ATTACHMENT B
Beaver Valley Power Station, Unit Nos. 1 and 2
Proposed Technical Specification Change No. 212 and 78
QUADRANT POWER TILT RATIO

A. DESCRIPTION OF AMENDMENT REQUEST

The proposed amendment would generally incorporate the Improved Standard Technical Specification (ISTS) guidance of NUREG-1431 into the definition of quadrant power tilt ratio (QPTR), Specification 3.2.4, "Quadrant Power Tilt Ratio," QPTR, associated Bases 3/4.2.4, Table 3.3-1 Action 2, and associated Bases 3/4.3.1 and 3/4.3.2.

ATTACHMENT E
Beaver Valley Power Station, Unit Nos. 1 and 2
Proposed Technical Specification Change Nos. 212 and 78
POWER RANGE CHANNEL DIAGRAM

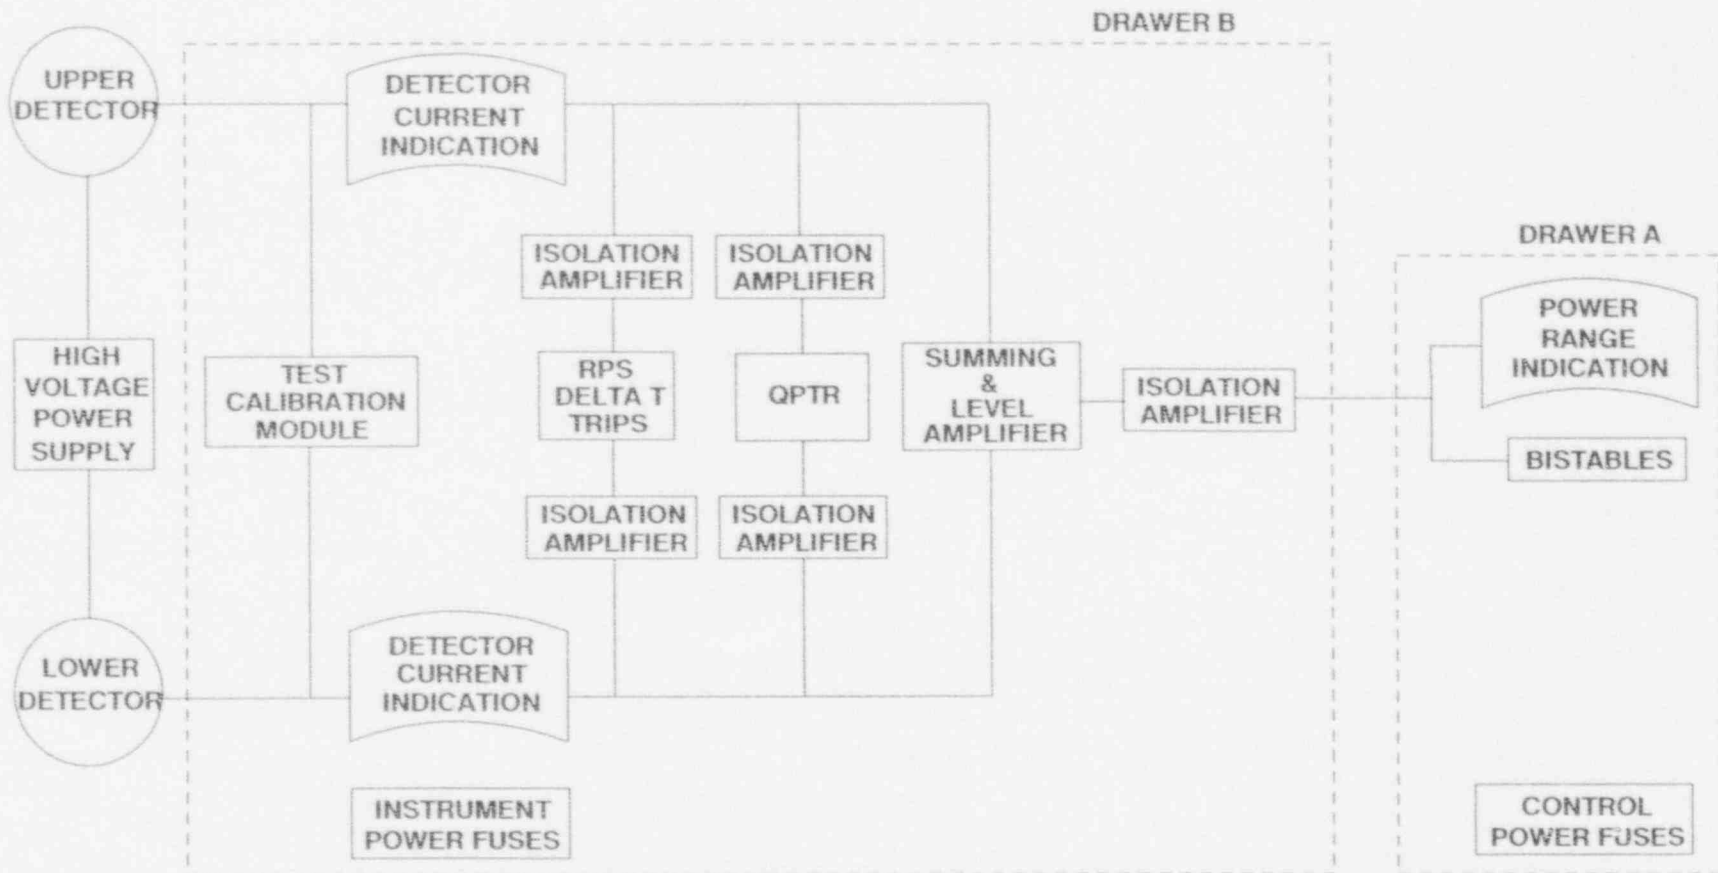
Note: As shown above, a power range channel may be inoperable due to control power fuses or an inoperable bistable, which would have no affect on the operator's ability to determine QPTR. Since there are many ways in which a power range channel may be declared inoperable, the proposed technical specification change separates the power range channel into two parts for QPTR verification purposes.
